**Subject:** 27 Bellevue Avenue, Avalon Beach NSW 2107 DA 2020/1162 WRITTEN  
SUBMISSION: LETTER OF OBJECTION Submission: Williams

Re:  
27 Bellevue Avenue, Avalon Beach NSW 2107  
DA 2020/1162

WRITTEN SUBMISSION: LETTER OF OBJECTION  
Submission: Williams

*Demolition of existing building and associated structures the construction of Seniors Housing under SEPP (Housing for Seniors or People with a Disability) 2004, at No. 27 Bellevue Avenue, Avalon Beach.*

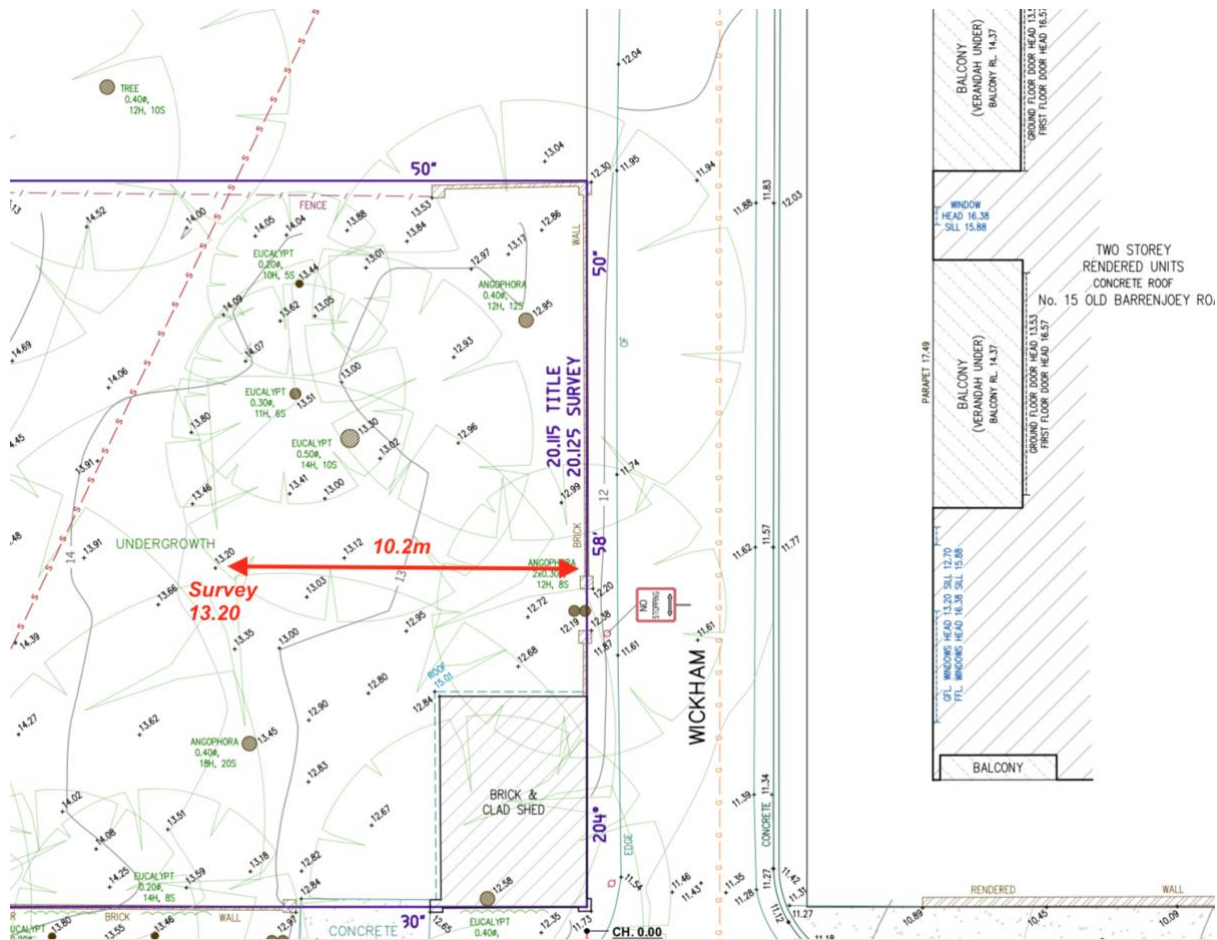
In this Submission we will contend that the proposed car park extends above ground by more than 1 metre, to a zone to a rear setback of 10.20m.

The proposed rear setback is just 3.25m, and therefore there is a substantial 313% non-compliance to SEPP HSPD controls.

The proposed Lower Ground Floor is at FFL 14.40, and a survey mark at 13.20 is positioned 10.2m from the rear boundary.

This represents a finished floor level 1.2m above this survey level, allowing for a 200mm slab.

We contend that as the proposed development is two storey in the rear quarter, then Council must impose a minimum rear setback of 6.5m.

It is our contention that the Lower Ground Floor must have a rear setback of 6.5m to better accord with Clause 40, and Control D1.9 of PDCP that provides that development in Avalon Beach on land zoned R2 Low Density Residential, R3 Medium Density Residential or E4 Environmental Living should have a rear setback of 6.5m.

1. Increase Rear Setback to 6.5m
2. Retain existing Trees in Rear Setback

3. Carpark to have a 6.5m Rear Setback
4. Landscape to fully cover the proposed development by dense vegetation screen facing Wickham Lane
5. Privacy Screens to windows facing Wickham Lane

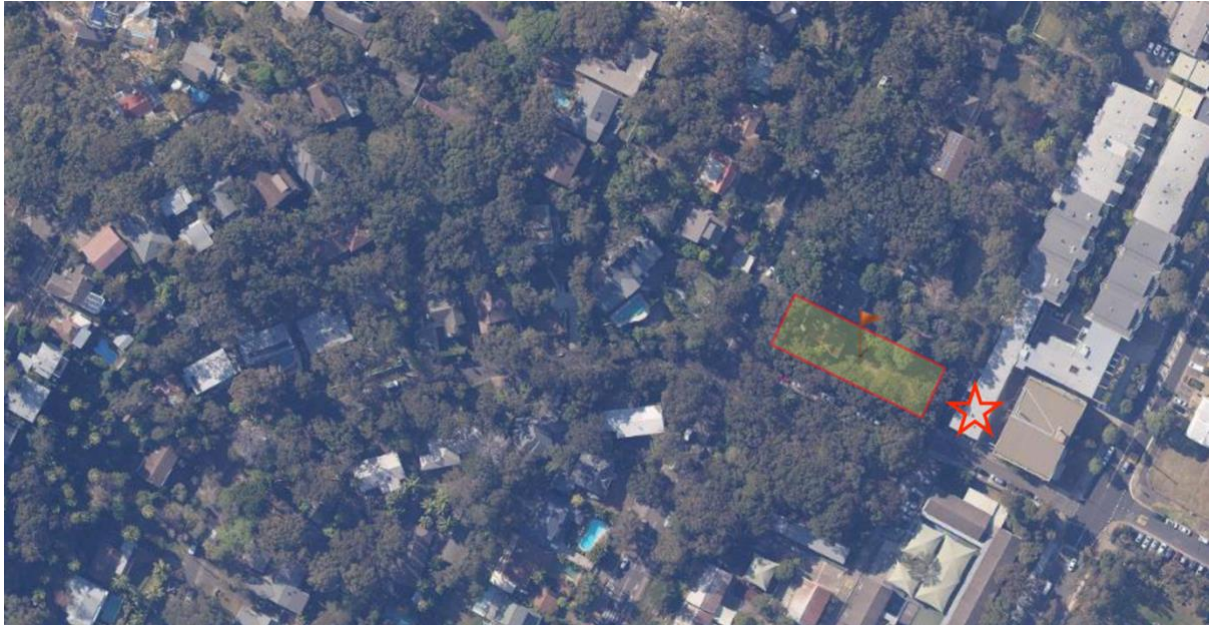
Our property is immediately across Wickham Lane from the proposed development with the subject property.

The subject site lies to the west of our property.

We enjoy extremely good levels of privacy, daylight access, and landscaped views over the subject site's rear boundaries.

Our property is shown on the attached map 'red starred'. The subject site is shown 'edged in red and flagged'.

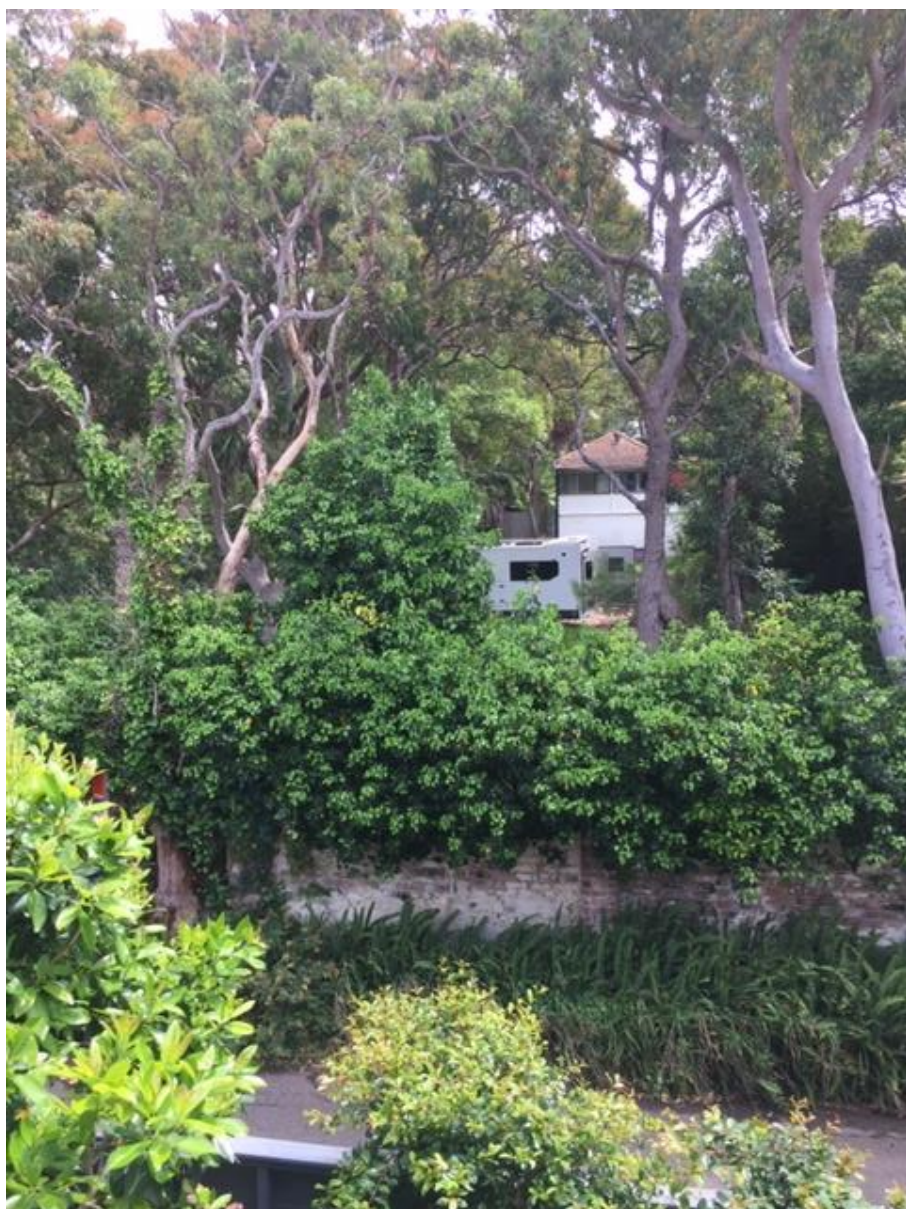
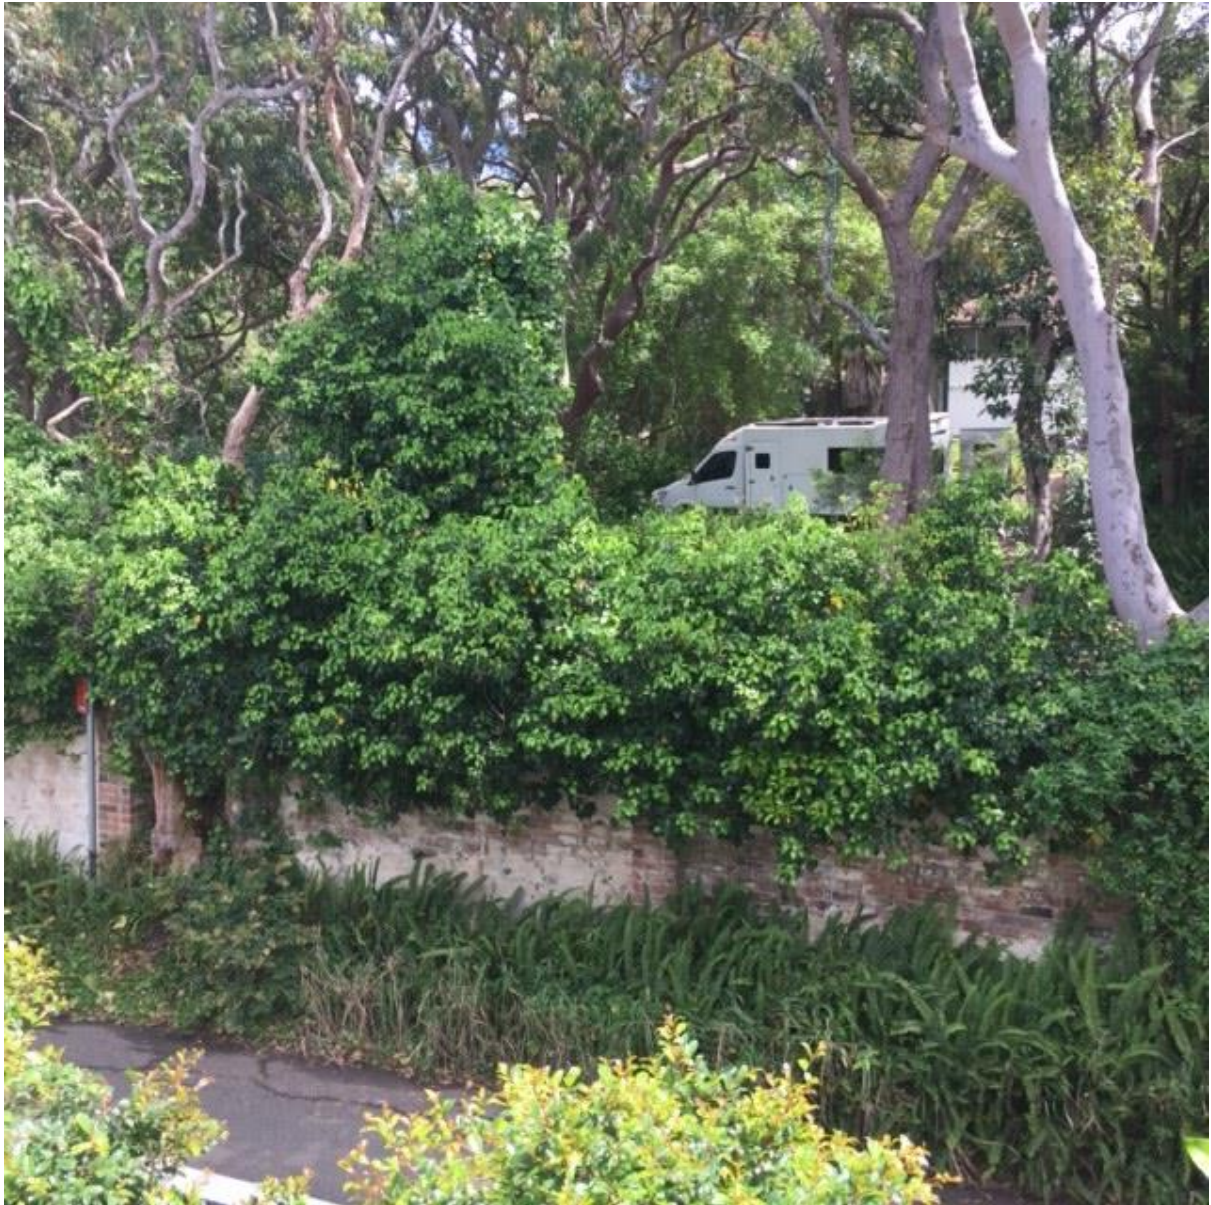
The following photographs show the current views from our property to clearly show the current leafy character of the view and outlook compared with what is proposed.
